CITY OF WESTMINSTER			
PLANNING APPLICATIONS COMMITTEE	Date 2 May 2017	Classification For General Release	
Report of Director of Planning		Ward(s) involved Lancaster Gate	
Subject of Report	13-14 Craven Terrace, London, W2 3QD		
Proposal	Erection of single storey rear extension at lower ground floor level and three storey rear extension at first to third floor levels, excavation of front light well with associated railings, replacement of shopfront to No. 14, demolition of water tank and installation of two air conditioning units within an acoustic enclosure at roof level; in association with refurbishment of hotel to increase hotel capacity.		
Agent	George Stamos		
On behalf of	Mr Raj		
Registered Number	16/11557/FULL	Date amended/ completed	23 January 2017
Date Application Received	6 December 2016		
Historic Building Grade	Unlisted		
Conservation Area	Bayswater

Reference: 16/11557/FULL

2. Proposed Rear Elevation
Scale: 1:100

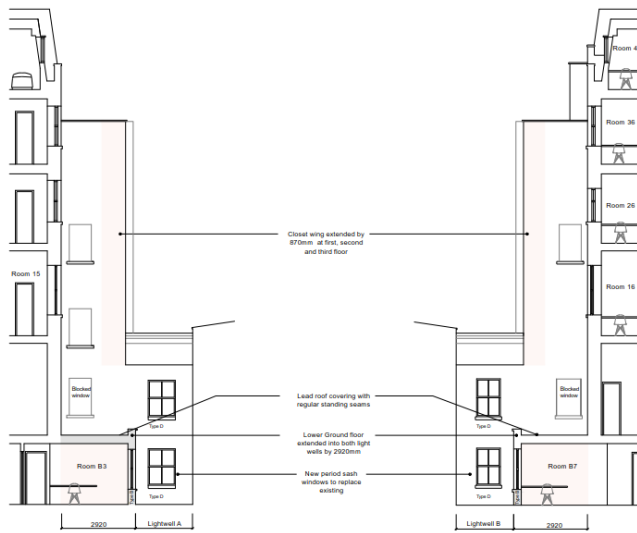
To the rear it is proposed to extend the closet wings by 870mm and to erect single storey extensions within the lower ground floor rear lightwells of both properties. The extensions are modest in scale and reflect the design and materiality of the existing building and are therefore acceptable in design and townscape terms and preserve the character and appearance of the building and the Bayswater Conservation Area.

In terms of detailed design, the alterations to the closet wings relate to two separate buildings and the introduction of a visual demarcation between the two closet wings is proposed in the form of 300mm projecting brickwork. This is a welcome approach as it ensures the interpretation of the two buildings is maintained. The roof is to be clad in lead and the rainwater goods will be black painted metal, which are welcomed. The windows are appropriately scaled and of a sympathetic design and materiality being white painted timber sashes. However the details of the windows do not appear to be accurate as the top sash sits within a double frame (the glazing should sit within the frame with the horns beneath). This is proposed to be secured by condition.

An objection from the occupier of the top floor flat within neighbouring building No. 15 Craven Terrace has been received on grounds that the rear extensions would result in a loss of daylight and an increased sense of enclosure to their bedroom window. The proposed extensions to the closet wing add less than 1m of depth, and this together with the distance from the neighbour's window in question, ensures that the extensions would not have any significant detrimental impact on the amount of daylight that the occupiers of the neighbouring property receive or result in any significant increased sense of enclosure. Furthermore, the originally proposed two storey extensions (lower ground and ground floor level within the rear lightwell) were, following officers advice reduced to lower ground floor level only. In their revised form, the reduced extensions would have limited impact on adjacent neighbours.

- 4 You must apply to us for approval of detailed drawings of the following parts of the development:
- 1) detailed drawings, including sections at a scale of 1:20 or 1:10 of the new windows;
 - 2) detailed drawings, of the new railings, including their method of fixing;
 - 3) detailed drawings, of the lower ground floor front elevation.

Existing and proposed roof plan

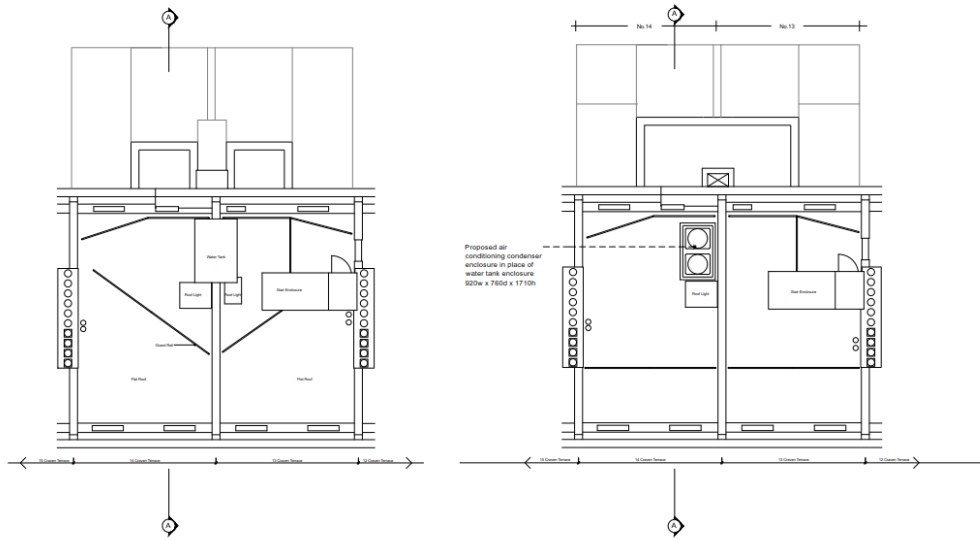
On the roof it is proposed to erect two new air conditioning condenser units, enclosed within an acoustic enclosure measuring 920mm by 760mm by 1710mm which will be powder coated dark grey to reflect the roofing material. The plant will replace an existing water tank of comparable scale and result in the removal of guard rails. Given the presence of an existing feature of this scale at roof level and the limited visibility of it from the street level and due to its set back from the front of the building, this installation is considered acceptable in design terms in this particular case.

Two air conditioning units are proposed on the roof of the building within an acoustic enclosure. An adjoining occupier has requested that conditions be imposed to ensure that the plant is not audible at adjoining properties. Environmental Health have reviewed the submitted acoustic report and are satisfied that it will comply with the Council's standard noise and vibration criteria which can therefore be secured by way of condition. A condition is also recommended to ensure the acoustic enclosure is installed prior to the operation of the plant.

- 7 The air conditioning unit must not operate until the mitigation measures specified in Part 5 of the Planning Compliance Review by KP acoustics dated 20 November 2016 have been installed and shall be retained for as long as the air conditioning unit remains in use.
